City of Rohnert Park  
Public Works Department

DATE: SEPTEMBER 5, 2025  
TO: ALL PLANHOLDERS  
SUBJECT: CITY OF ROHNERT PARK  
BENICIA PARK CONCESSION STAND RENOVATION  
PROJECT  
NO. OF PAGES: 13

### ADDENDUM NO. 1

BENICIA PARK  
CONCESSION BUILDING  
FIRE REPLACEMENT  
7471 BERNICE AVENUE  
ROHNERT PARK, CA 94928

1 DOOR TYPE  
1/2"=1'-0"

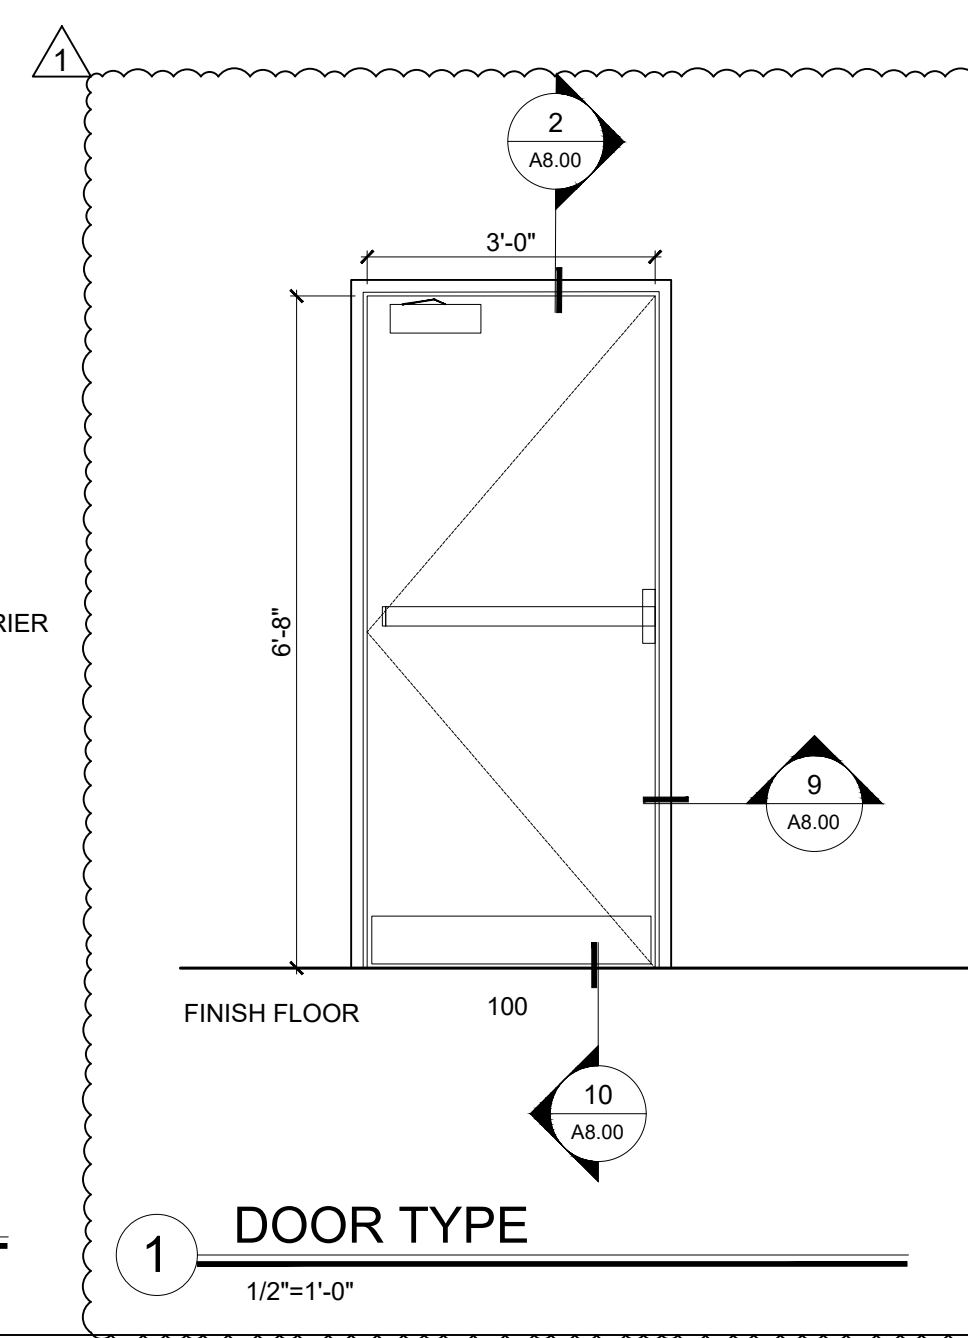
### **Sheet A8.00**

- Detail 1, updated door hardware to reflect Push Rail and Lever Hardware
